SERVICE BULLETIN

SUBARU CORPORATION
Customer Quality Dept.
Japan.

Issued: May 21, 2021
Rev1 Jun. 29, 2021
Rev2 Dec 27, 2021

Subject:	Repair Procedure Correction/Addition: Countermeasures against Knocking and/or DTC P030x on FB2.0L DI engines.
Applicable Section in Service Manual:	Engine > FUEL INJECTION (FUEL SYSTEMS) > Fuel Injector
Applicable Parts name in Parts System:	INTAKE MANIFOLD > INJECTOR SUB ASSEMBLY
Foreword:	<p>This service bulletin is to inform you of new countermeasure part for FB2.0L DI engine Knocking and/or DTC P030x.</p> <p>Rev1: Added affected parts (Flow rate MARK7, 8,9) numbers.</p> <p>Rev2: Added 22MY BRZ as affected model.</p>

4-1 Identification

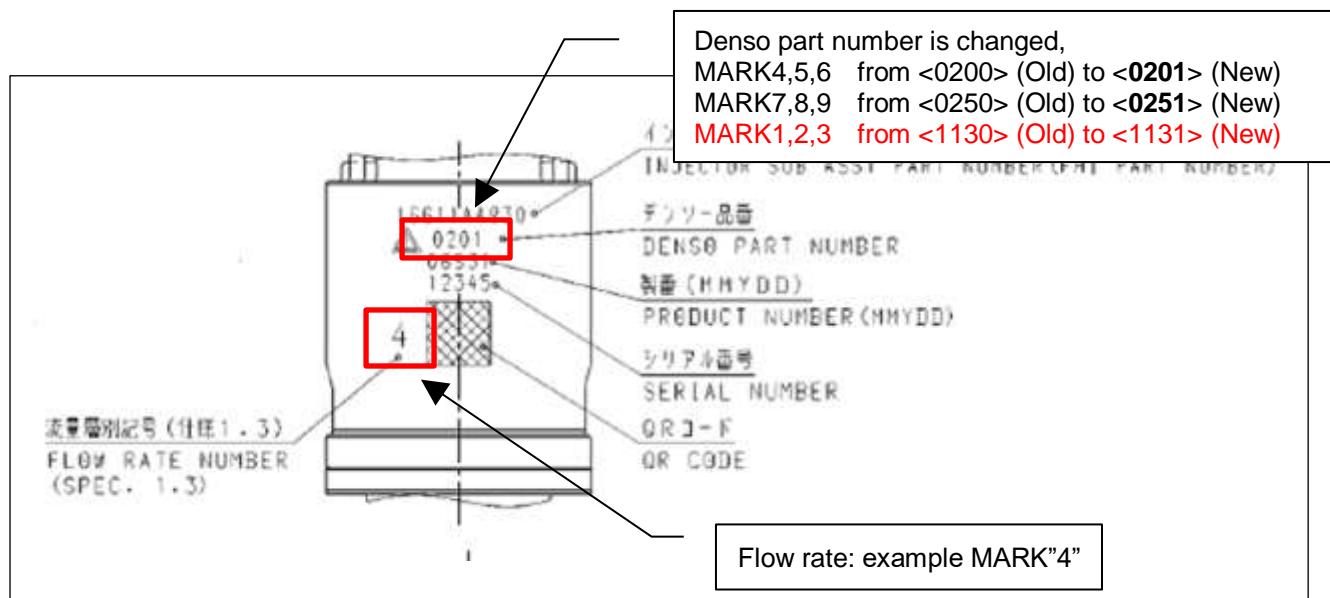
The improved part is identifiable by looking at the supplier's part number engraved on the injector body as shown below.
